City of Pembroke Pines
Planning & Economic Development Department
601 City Center Way 3rd Floor
Pembroke Pines FL, 33025

Agenda Date:	September 14, 2023	Application ID:	SP 2023-0001
Project:	West Pines Plaza	Project Number:	PRJ 2023-0001
Project Planner	Joseph Yaciuk, Assistant Director		
Owner:	HAC PINES, LLC	Agent:	Dwayne L. Dickerson
Location:	South of Pines Boulevard and west of SW 186 Avenue		
Existing Zoning:	B-3 (General Commercial)		
Existing Land Use:	Commercial		
Reference Applications:	SP 2015-13, ZC 2015-03, SUB 2014-01		
Applicant Request:	The applicant proposes the construction of a new retail plaza with associated parking, lighting, signage, and landscaping.		
Staff Recommendation:	Approval.		
Final:	<input checked="" type="checkbox"/> Planning & Zoning Board	<input type="checkbox"/> City Commission	
Reviewed for the Agenda:	Director:  Assistant Director:

PLANNING DIVISION STAFF COMMENTS

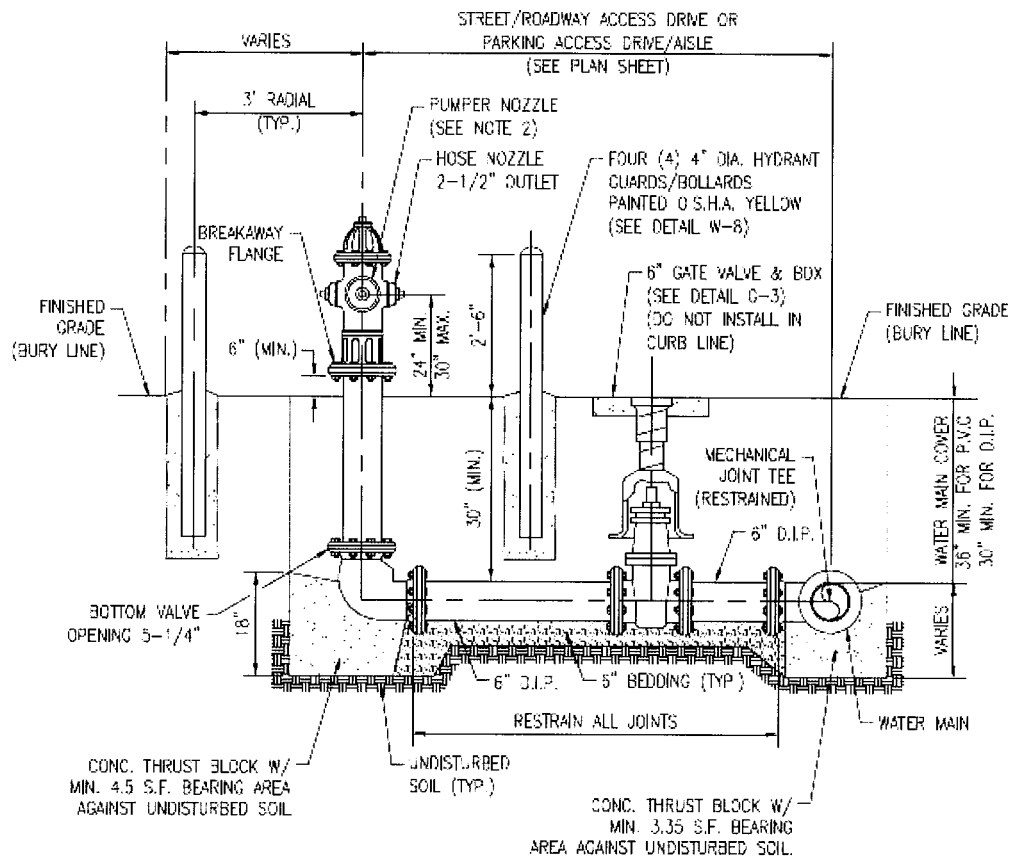
See Fire Lane Detail.

FIRE HYDRANT DETAIL

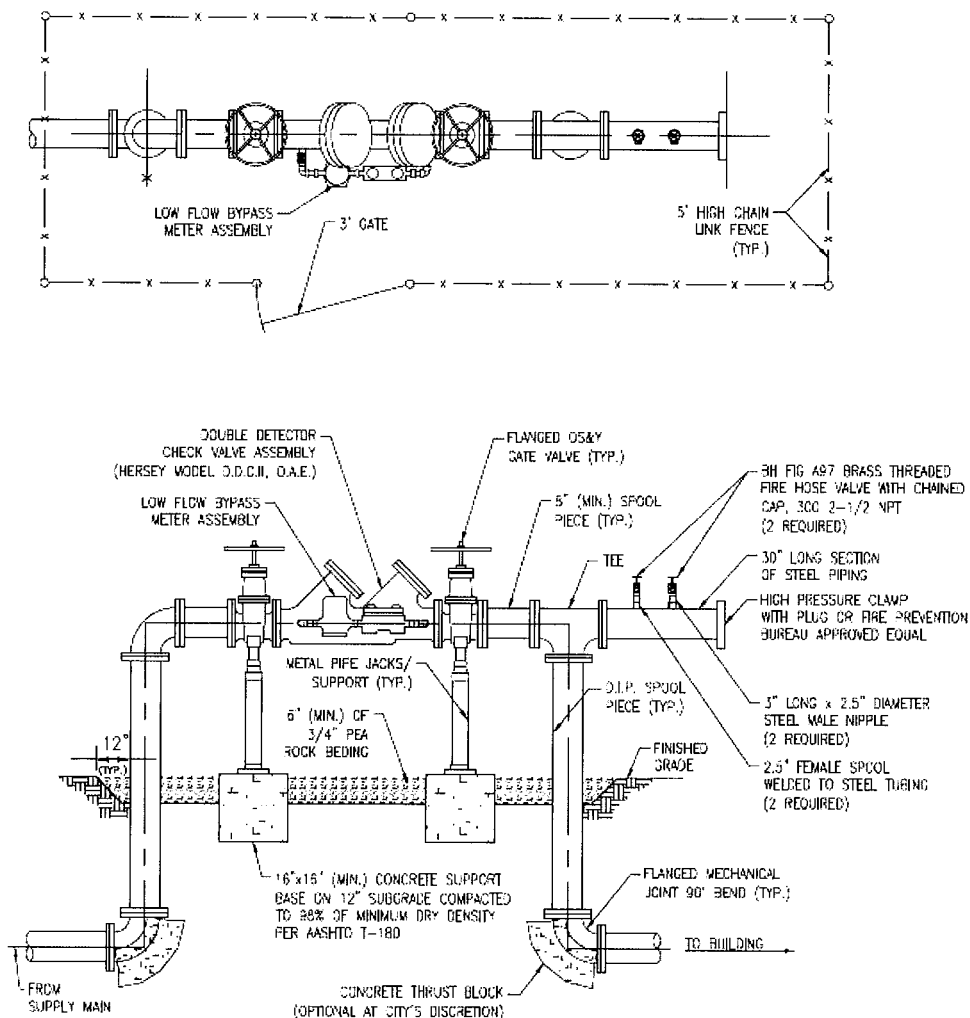
NOTE: Fire Hydrant Detail to be provided on submittal.
